Access Compliance Report Public Rights-of-Way (Curb Ramps)

Intersection ID: 4865 Main Street: HENDERSON CR Cross Street: CRYSTAL_CREST_WY Location: SE ADA ID: 4115FB803A08 Ramp Type: Directional1 Initial Pass/Fail: Fail **Overall Compliance: No** Severity Score: 21.25

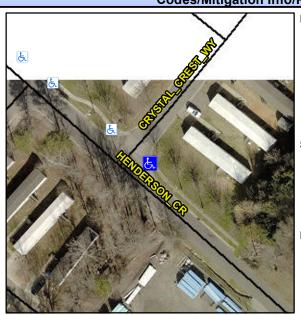
Field Measurements/Component Compliance					
Compliance Description		Data	Compliance Description		Data
N/A	Ramp Length (in)	23.0	N/A	Grade Break?	N/A
No	Ramp Width (in)	45.0	N/A	Grade Break Slope (%)	0.0
No	Ramp Slope (%)	10.9	N/A	Grade Break XSlope (%)	0.0
Yes	Ramp XSlope (%)	0.7			
N/A	Flare Type LT	N/A	N/A	Flare Type RT	N/A
N/A	Flare Slope LT (%)	N/A	N/A	Flare Slope RT (%)	0.0
N/A	Flare Traversable LT?	N/A	N/A	Flare Traversable RT?	N/A
N/A	Landing Length (in)	0.0	N/A	DWS Provided?	N/A
N/A	Landing Width (in)	0.0	N/A	DWS Contrast?	N/A
N/A	Landing Slope (%)	0.0	N/A	DWS Length (in)	N/A
N/A	Landing X Slope (%)	0.0	N/A	DWS Full Width?	N/A
N/A	Landing Curb? (Y/N)	N/A	N/A	DWS Offset LT (in)	N/A
N/A	Shared Landing?	N/A	N/A	DWS Offset RT (in)	N/A
N/A	Gutter Ponding?	0.0	N/A	Gutter Slope (%)	N/A
N/A	Gutter Lip Ht (in)	0.0	N/A	Gutter X Slope (%)	N/A
N/A	Painted X Walk1?	No		Road Slope (%)	5.4
	X Walk 1 Direction	To NW		Road X Slope (%)	5.4

CRYSTAL CREST WY Street 1 Name Stop Condition-Street 1 StopSign Street 2 Name N/A Stop Condition-Street 2 N/A Possible Solutions: Remove & Replace Entire Ramp. Surveyor Notes: N/A PROW/ADA: R304.5.1, R304.2.2
